CASE NO: 2010-6028-01; 2016-9001-00  
 TITLE: GENERAL NOTES  
 DATE: DECEMBER 28, 2016

CASE NO: 2010-6028-01; 2016-9001-00  
TITLE: SITE PLAN  
DATE: DECEMBER 28, 2016

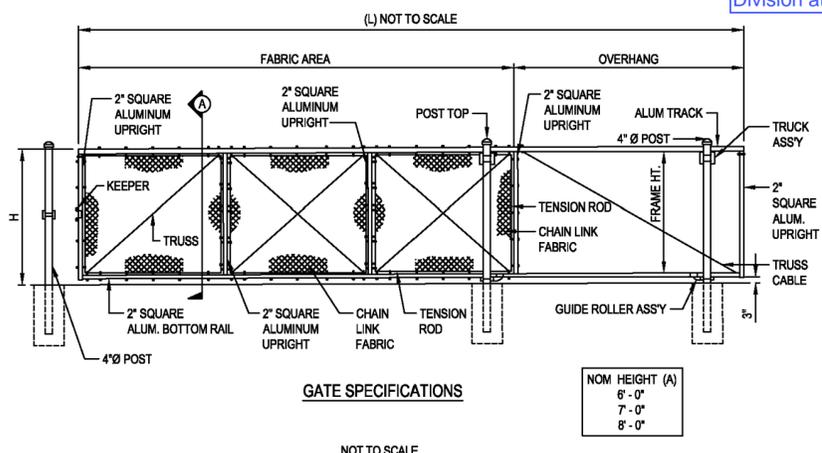
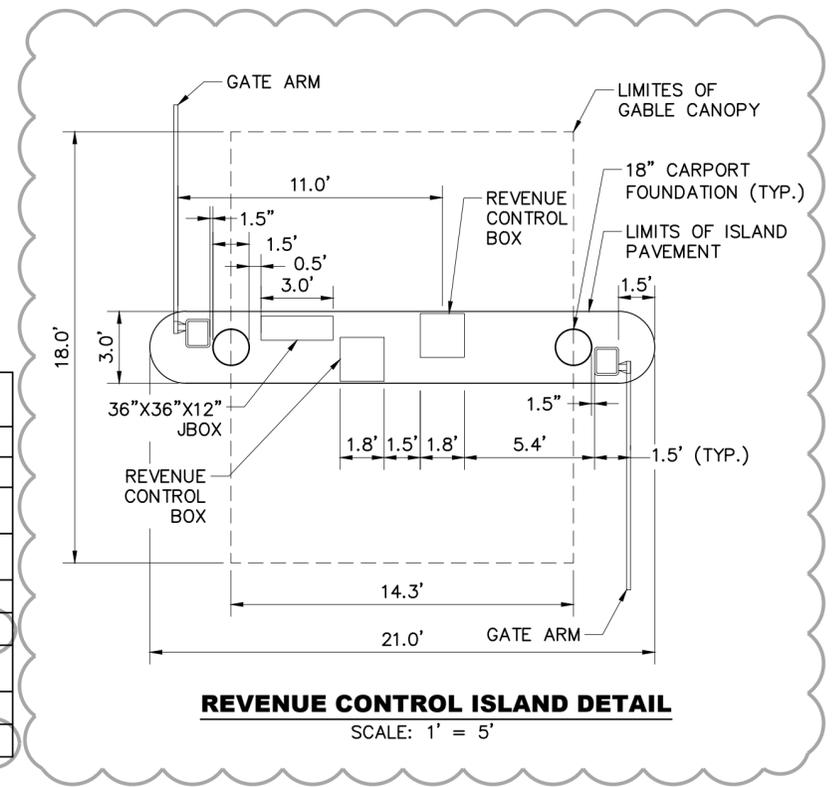
- THE DEVELOPER, HIS SUCCESSORS AND ASSIGNS INCLUDING THE HOMEOWNERS ASSOCIATION SHALL BE RESPONSIBLE FOR THE INSTALLATION, MAINTENANCE, AND REPLACEMENT OF THE ACCESS CONTROL GATE OR BARRIER SYSTEM REQUIRED BY THE CITY. **Add the following note: THE DEVELOPER, HIS OR HER SUCCESSORS, AND ASSIGNS SHALL BE RESPONSIBLE FOR INSTALLATION, MAINTENANCE, AND REPLACEMENT OF THE ACCESS CONTROL GATE OR BARRIER SYSTEM TO ENSURE EMERGENCY VEHICLE ACCESS TO WITHIN THE SITE. IF THE ABOVE CONDITIONS ARE NOT MET, THE OWNERS, HIS OR HER SUCCESSORS, AND ASSIGNS, SHALL BE REQUIRED BY FIRE DEPARTMENT ORDER NOTICE THAT ALL AFFECTED GATES WILL BE CHAINED AND LOCKED IN THE OPEN POSITION UNTIL REPAIRED OR REPLACED, AND RETESTED. IF THE GATING SYSTEM IS NOT MAINTAINED TO THE SATISFACTION OF THE FIRE DEPARTMENT, THE LICENSE AGREEMENT FOR THE EMERGENCY VEHICLE GATE OPENING SYSTEM WILL BE REVOKED AND THE GATING SYSTEM MUST BE REMOVED. THE GATING SYSTEM WILL INCLUDE AN EMERGENCY VEHICLE GATE OPENING SYSTEM UTILIZING A REDUNDANCY BACK-UP SYSTEM THAT CONSISTS OF; A) SIREN OPERATED SYSTEM; B) AUTOMATIC KNOX KEY SWITCH; AND C) MANUAL OVERRIDE (IN THE EVENT OF SYSTEM FAILURE). GATING SYSTEMS WILL BE INSTALLED IN ACCORDANCE WITH THE "GATING SYSTEMS CROSSING FIRE APPARATUS ACCESS ROADS CHECKLIST". A SEPARATE BUILDING PERMIT THROUGH THE BUILDING DIVISION IS REQUIRED TO BE OBTAINED BY THE CONTRACTOR PRIOR TO THE INSTALLATION OF ANY GATING/BARRIER SYSTEM THAT CROSSES A DEDICATED FIRE LANE EASEMENT.**

The installation of any gating system will require a City of Aurora licensed contractor to obtain a building permit through the Aurora Building Division prior to the start of any work. This would be considered a structural, life safety and electrical review within the Building Division that is conducted on behalf of the Fire Chief. For assistance please call 303-739-7420 and ask for a Life Safety Plans Examiner.

The installation of any shade shelters/canopies will require a separate City of Aurora building permit prior to the start of any work. For assistance please call the City of Aurora Building Division at 303-739-7420.

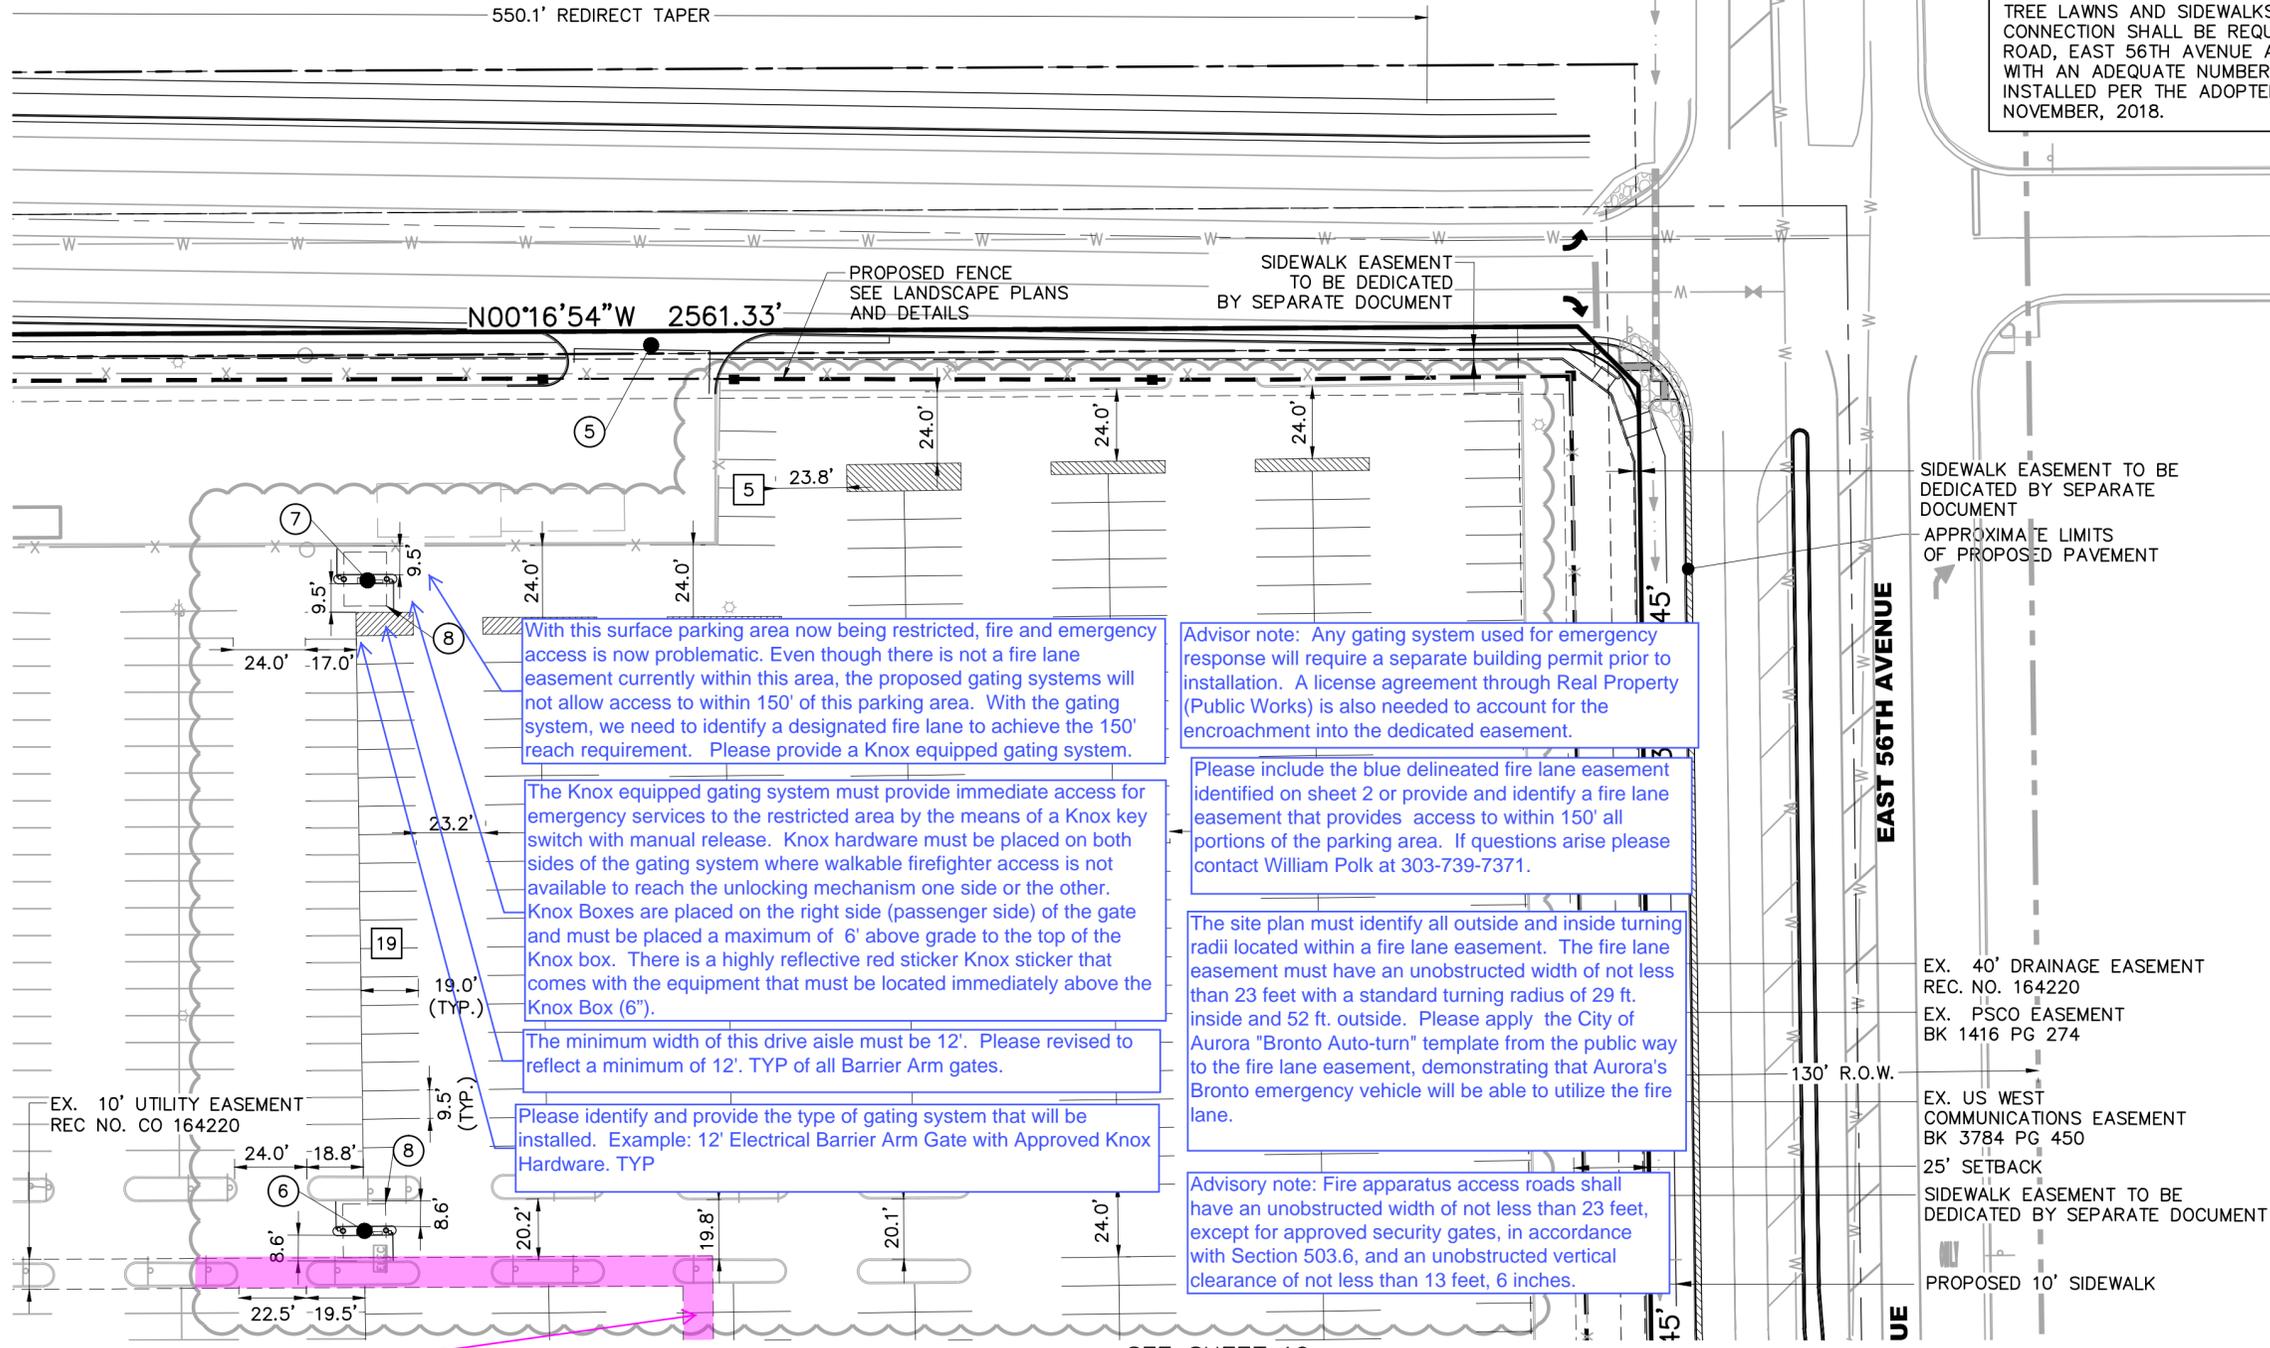
There are about 15 covered spaces that will need to be eliminated due to the Existing Utility easement. Per City Code no permanent structures are allowed in the easement. The canopy will need to be revised to meet City Code. See the site plan and supplemental drawing for reference.

With this surface parking area now being restricted, fire and emergency access is now problematic. Even though there is not a fire lane easement currently within this area, the proposed gating systems will not allow access to within 150' of this parking area. With the gating system, we need to identify a designated fire lane to achieve the 150' reach requirement. Please provide a Knox equipped gating system.

Advisor note: Any gating system used for emergency response will require a separate building permit prior to installation. A license agreement through Real Property (Public Works) is also needed to account for the encroachment into the dedicated easement.

The Knox equipped gating system must provide immediate access for emergency services to the restricted area by the means of a Knox key switch with manual release. Knox hardware must be placed on both sides of the gating system where walkable firefighter access is not available to reach the unlocking mechanism one side or the other. Knox Boxes are placed on the right side (passenger side) of the gate and must be placed a maximum of 6' above grade to the top of the Knox box. There is a highly reflective red sticker Knox sticker that comes with the equipment that must be located immediately above the Knox Box (6").

Please include the blue delineated fire lane easement identified on sheet 2 or provide and identify a fire lane easement that provides access to within 150' all portions of the parking area. If questions arise please contact William Polk at 303-739-7371.

The minimum width of this drive aisle must be 12'. Please revised to reflect a minimum of 12'. TYP of all Barrier Arm gates.

The site plan must identify all outside and inside turning radii located within a fire lane easement. The fire lane easement must have an unobstructed width of not less than 23 feet with a standard turning radius of 29 ft. inside and 52 ft. outside. Please apply the City of Aurora "Bronto Auto-turn" template from the public way to the fire lane easement, demonstrating that Aurora's Bronto emergency vehicle will be able to utilize the fire lane.

Please identify and provide the type of gating system that will be installed. Example: 12' Electrical Barrier Arm Gate with Approved Knox Hardware. TYP

Advisory note: Fire apparatus access roads shall have an unobstructed width of not less than 23 feet, except for approved security gates, in accordance with Section 503.6, and an unobstructed vertical clearance of not less than 13 feet, 6 inches.

the canopies in the area of the existing Utility easement will not be able to be constructed over the utility easement

CASE NO: 2010-6028-01; 2016-9001-00  
TITLE: SITE PLAN  
DATE: DECEMBER 28, 2016

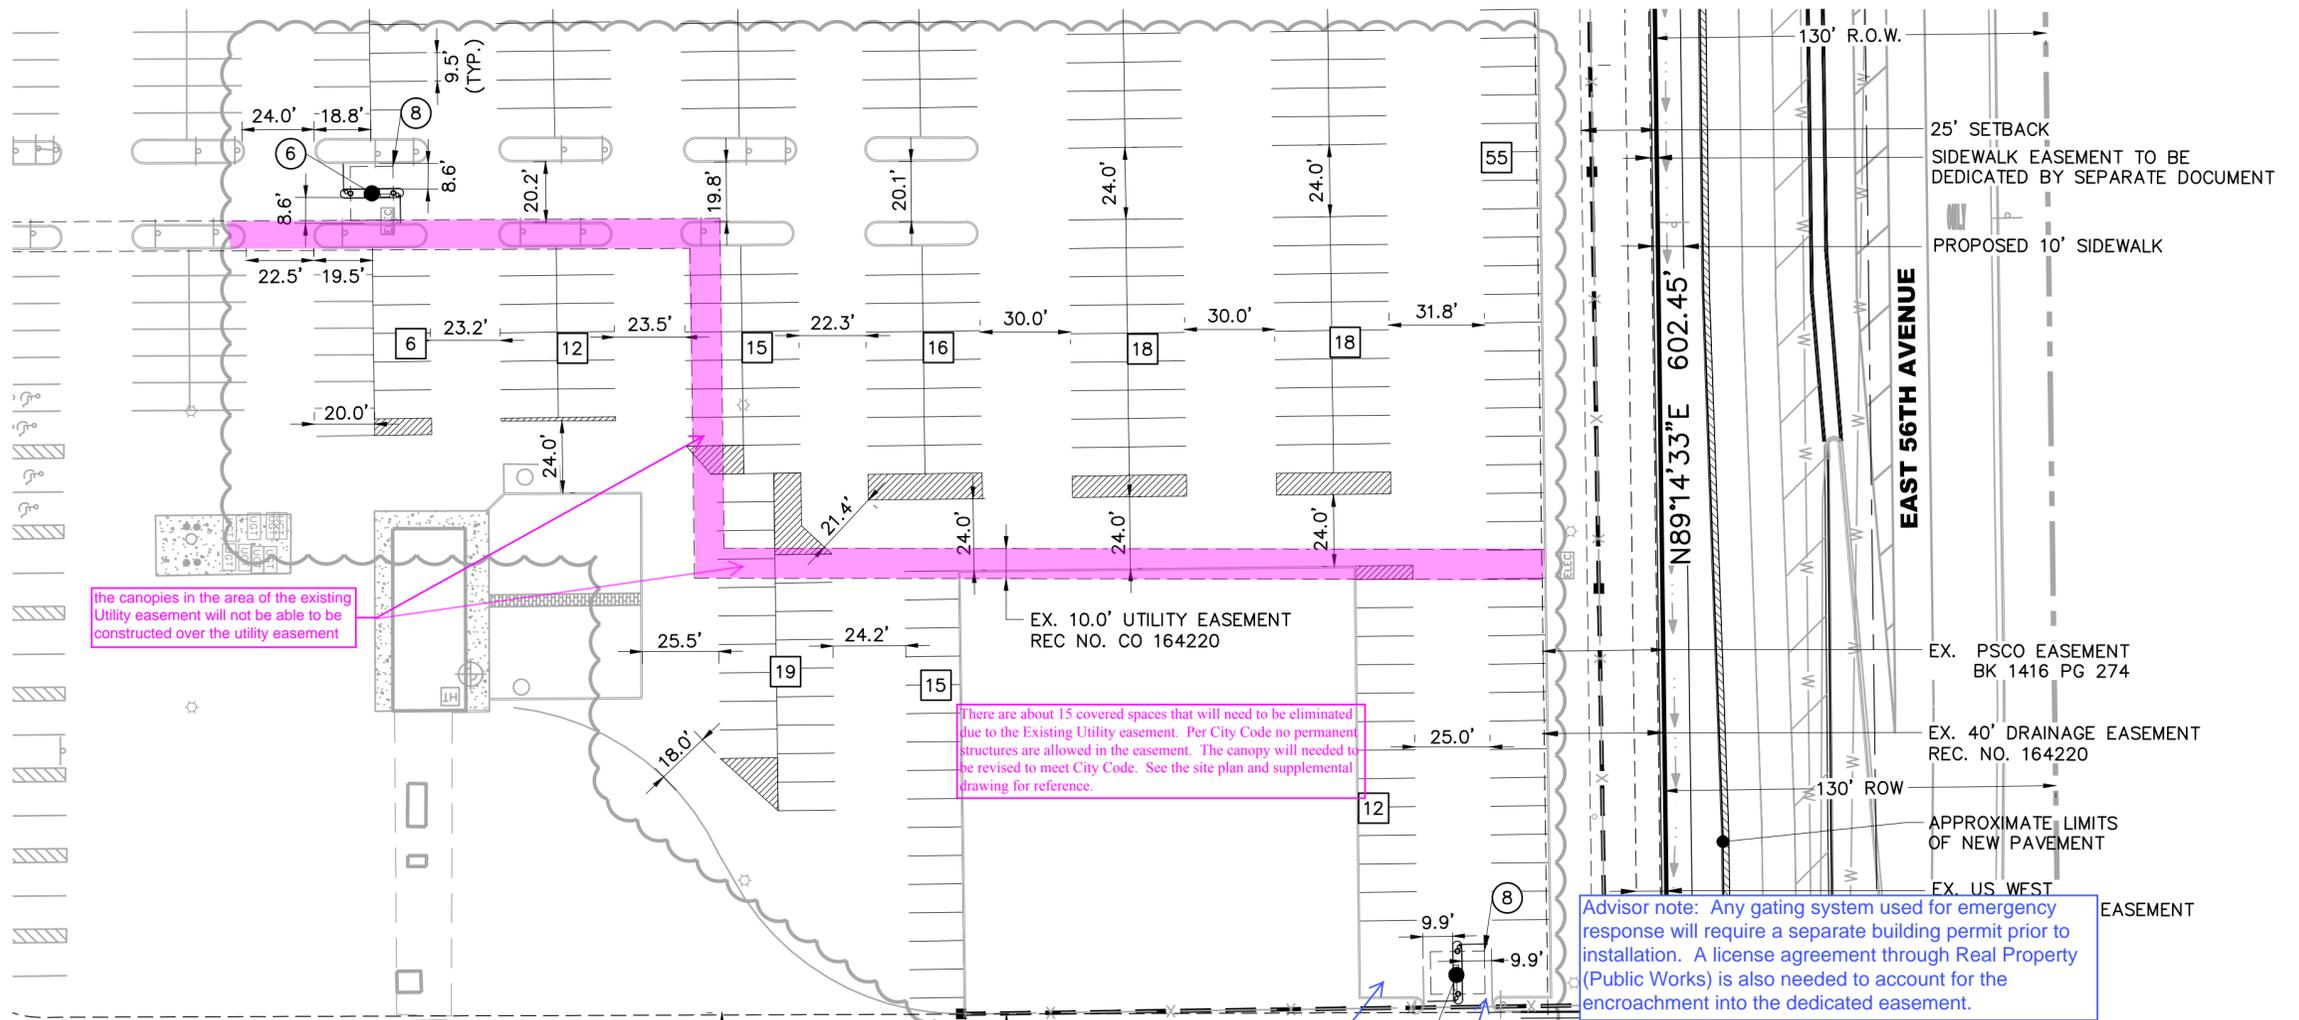
the canopies in the area of the existing Utility easement will not be able to be constructed over the utility easement

There are about 15 covered spaces that will need to be eliminated due to the Existing Utility easement. Per City Code no permanent structures are allowed in the easement. The canopy will need to be revised to meet City Code. See the site plan and supplemental drawing for reference.

Advisor note: Any gating system used for emergency response will require a separate building permit prior to installation. A license agreement through Real Property (Public Works) is also needed to account for the encroachment into the dedicated easement.

The minimum width of this drive aisle must be 12'. Please revised to reflect a minimum of 12'. TYP of all Barrier Arm gates.

With this surface parking area now being restricted, fire and emergency access is now problematic. Even though there is not a fire lane easement currently within this area, the proposed gating systems will not allow access to within 150' of this parking area. With the gating system, we need to identify a designated fire lane to achieve the 150' reach requirement. Please provide a Knox equipped gating system.

The site plan must identify all outside and inside turning radii located within a fire lane easement. The fire lane easement must have an unobstructed width of not less than 23 feet with a standard turning radius of 29 ft. inside and 52 ft. outside. Please apply the City of Aurora "Bronto Auto-turn" template from the public way to the fire lane easement, demonstrating that Aurora's Bronto emergency vehicle will be able to utilize the fire lane.

The Knox equipped gating system must provide immediate access for emergency services to the restricted area by the means of a Knox key switch with manual release. Knox hardware must be placed on both sides of the gating system where walkable firefighter access is not available to reach the unlocking mechanism one side or the other. Knox Boxes are placed on the right side (passenger side) of the gate and must be placed a maximum of 6' above grade to the top of the Knox box. There is a highly reflective red sticker Knox sticker that comes with the equipment that must be located immediately above the Knox Box (6").

Please include the blue delineated fire lane easement identified on sheet 2 or provide and identify a fire lane easement that provides access to within 150' all portions of the parking area. If questions arise please contact William Polk at 303-739-7371.

Advisory note: Fire apparatus access roads shall have an unobstructed width of not less than 23 feet, except for approved security gates, in accordance with Section 503.6, and an unobstructed vertical clearance of not less than 13 feet, 6 inches.
